Response to TCB Findings

Freq. Response of Audio

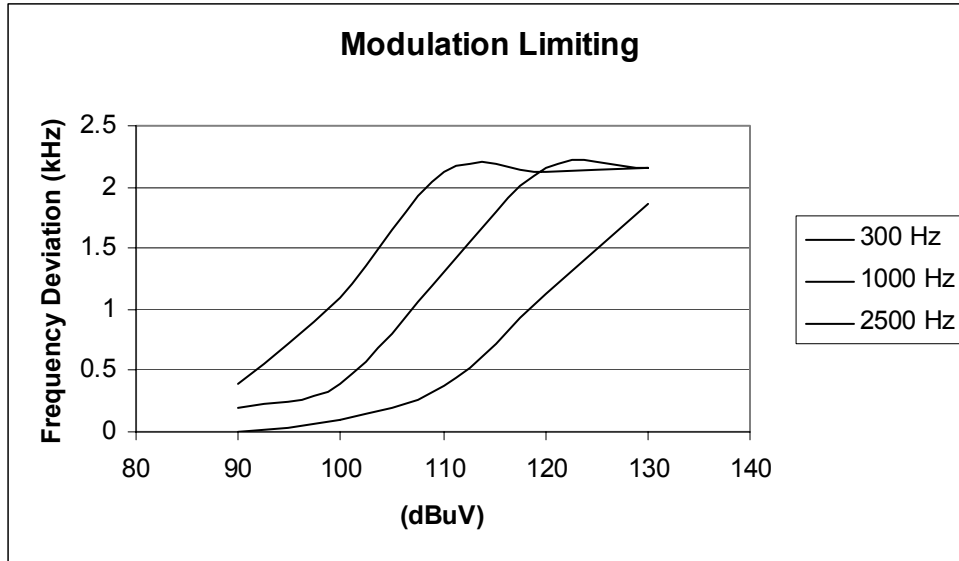
1. A curve or equivalent data showing the frequency response of the audio modulating circuit over a range of 100 to 5000Hz shall be supplied as required by 2.1047(a).

Response

25kHz Ch. Spacing

I/P Freq. (Hz)	Demod. O/P (dB)
100	-72.2
300	-19.1
500	-14.1
1500	-3.9
2000	-1.5
2500	0.2
3000	0
3500	-23
4000	-74.2
5000	-76.2

12.5kHz Ch. Spacing

I/P Freq. (Hz)	Demod. O/P (dB)
100	-67.5
300	-19.2
500	-14
1500	-4.1
2000	-1.6
2500	0.4
3000	0
3500	-23
4000	-71.5
5000	-70.5

UT-4D4XX, Modulation Limiting
NB

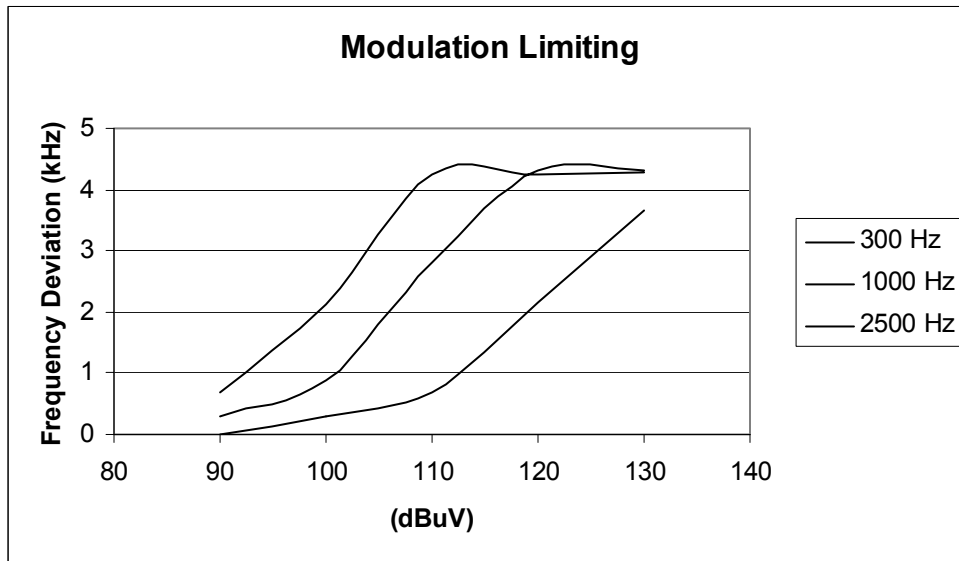
2. Please supply modulation limiting curve required by 2.1047(b).

Response

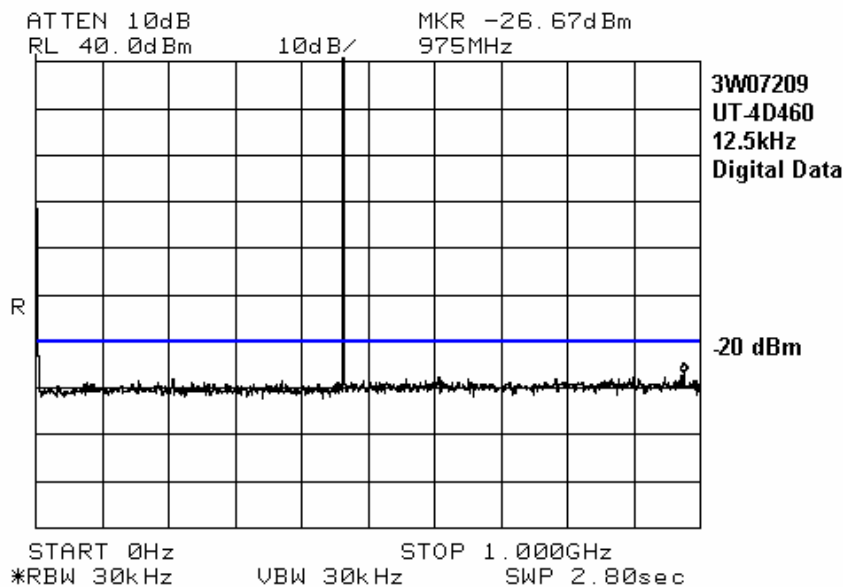
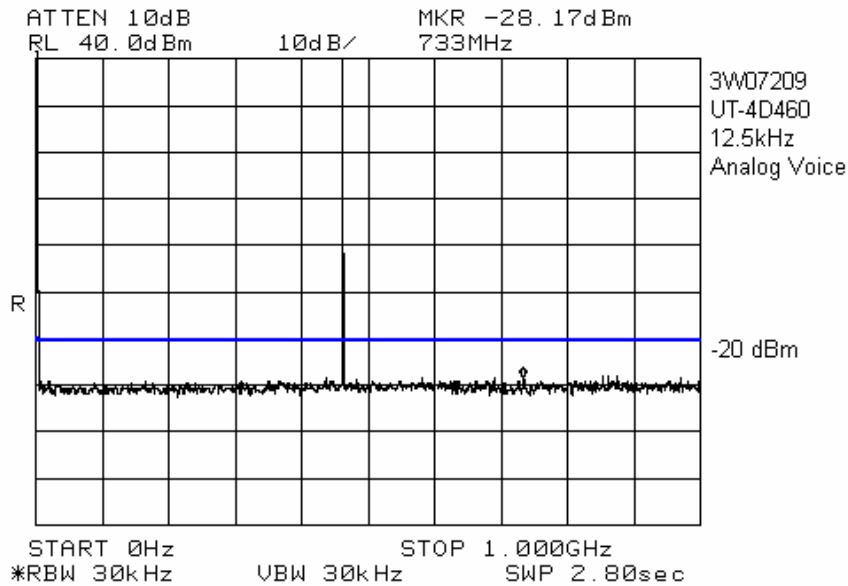
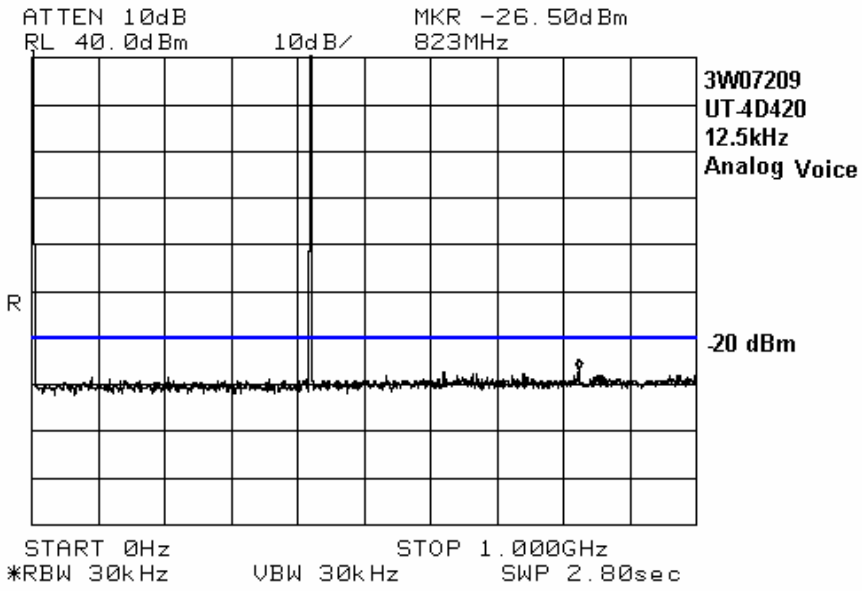
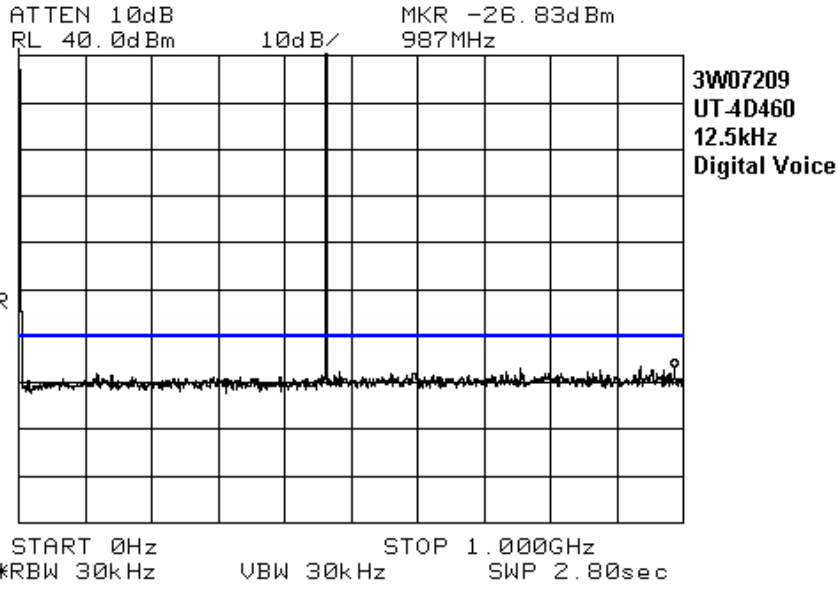
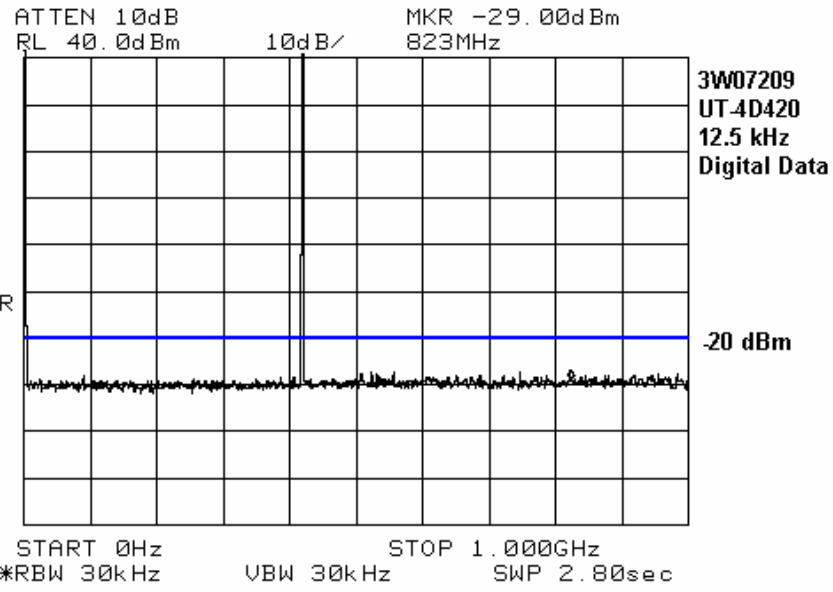
3. For some of the spurious emissions at the antenna terminal plots the in the test report RBW is set to 10kHz. The minimum RBW setting should be 30kHz according to 22.359(c). Please justify/clarify this selection

This test caused a dilemma. Part 22 and Part 90 have different requirements. P22 uses 30 kHz, P90 uses at least 10kHz(see 90.210(m)). I showed 10 kHz assuming it would be relatively easy to calculate emission peaks from a 10 kHz to 30kHz RBW/VBW. It would also show a truer representation of the EUT, by lowering the N.F. of the analyzer. See attached plots.
